Meeting: 3/16/2022
Applicant: Amber Culpepper Lafayette Investments LLC
Owner: Amber Culpepper Lafayette Investments LLC

Location: 3421 Gap Rd. **Parcel ID** 81 | T 008
Zoning: RN-2 (Single-Family Residential Neighborhood)
District: Lonsdale Infill Housing Overlay District

Level III New Primary Structure

3-K-22-IH

1 Site Setbacks & Layout
 A100 1" = 20'-0"

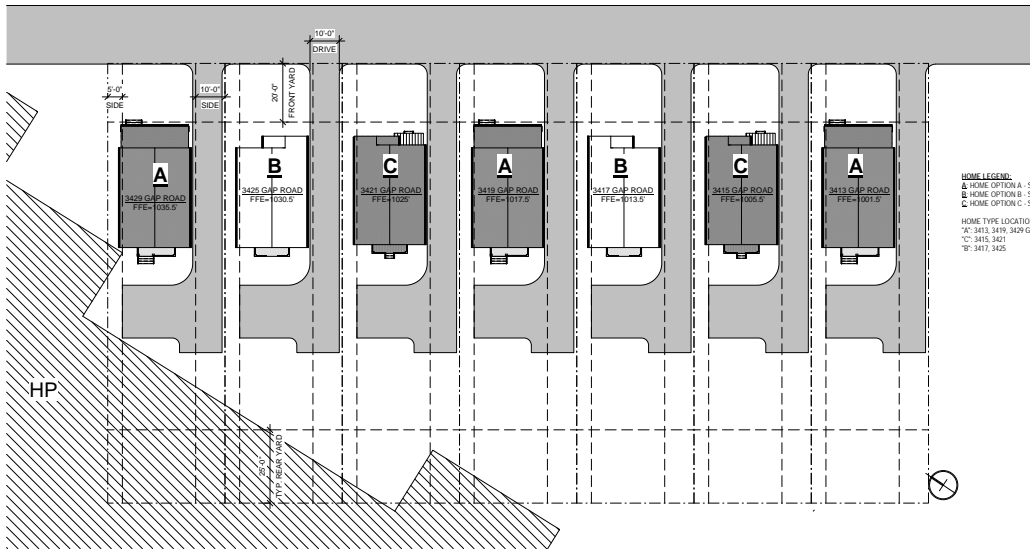
1. The proposed front setback is 24' from the front property line. There are only three other houses on the block. 3401 Gap Road is located 42' from the front property line, and the new construction houses at 3405 and 3409 Gap Road are also set 42' from the front property line. The subject property is one of seven new houses to be constructed on the block, so the front setbacks will effectively create a new street pattern. The submitted site plans do not specifically call out the front setback measurement. Overall, the proposed front setbacks should be confirmed to create consistent front yard spaces along the block.

The seven adjacent new houses will demonstrate consistent side yard setbacks while accommodating the necessary side driveways. The applicant should confirm the left side exterior walls of all 7 houses will stay within the 5' side setback required allow windows on side elevation walls.

- 1) Front setback should be confirmed to create consistent front yard space along the block, with approval of final site plans by staff;
- 2) Left side setback to be a minimum of 5', so the left side elevations can retain windows;
- 3) Final site plan to meet City Engineering standards and Infill Housing design guidelines;
- 4) Revise design of front porch to meet design guidelines, with approval by staff;
- 5) Add one bay of windows on the left side elevation, with approval by staff;
- 6) Final site plan to show one tree in front and one tree in rear yard.

1 01 - Main Level
 C-103 1/4" = 1'-0"

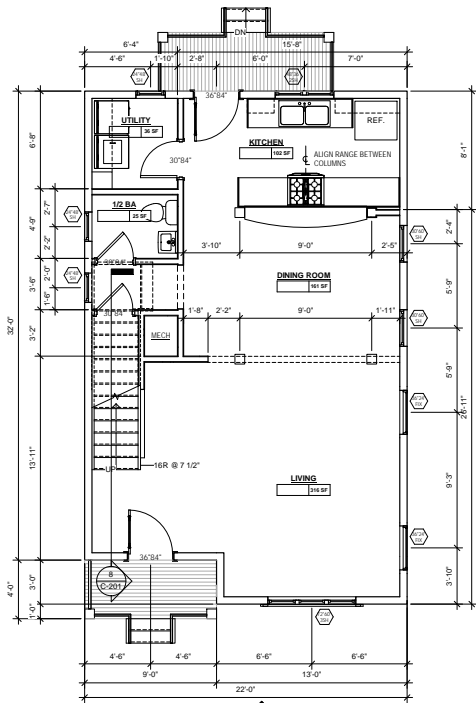
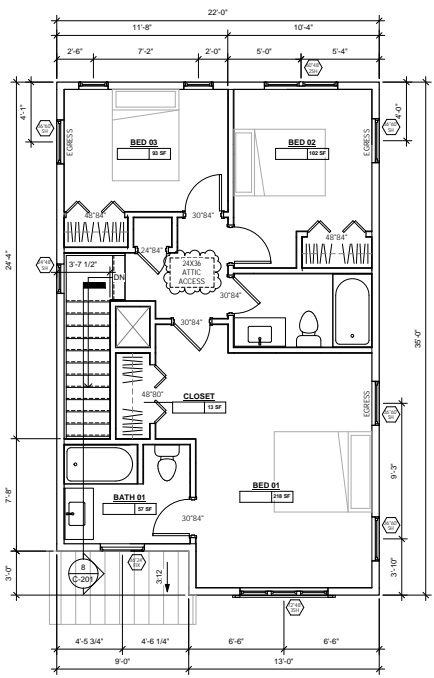
5. Design "C" proposes a 3' wide entry stoop instead of a porch. The new house should incorporate a porch to meet design guidelines, measuring 8' deep and with a roof proportionate to the overall design.

4 East
 1/4" = 1'-0"

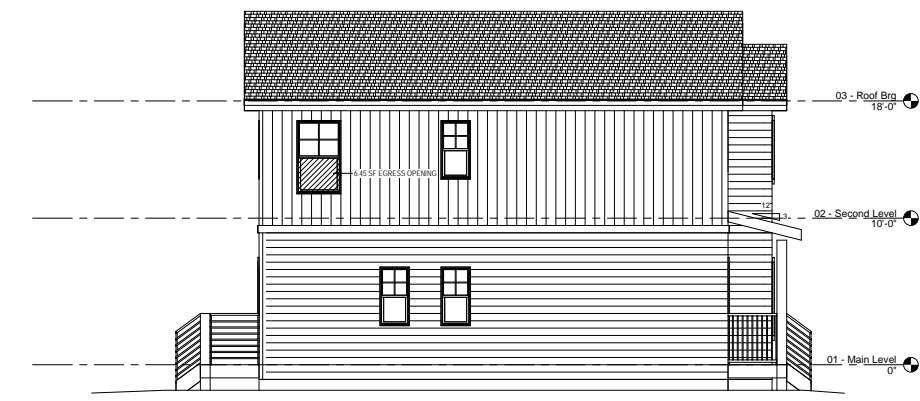
6. Guidelines note that "window and door styles should be similar to original or historic houses" in the surrounding context. 1/1 windows instead of the proposed 4/1 would be more appropriate for the surrounding context. The façade generally shows "similar proportion and position as original houses on the block," though the single fixed window is disproportionately small to the façade. The side elevations show multiple sizes of windows with somewhat irregular placement. The left side elevation would benefit from an additional bay of windows closer to the façade, as the large swath of wall with no transparency will be significantly visible from the street.

7. At 6/12, the roof has a similar pitch to original houses in the neighborhood. The 3/12 pitch, shed roof will be somewhat shallow in proportion to the rest of the house.
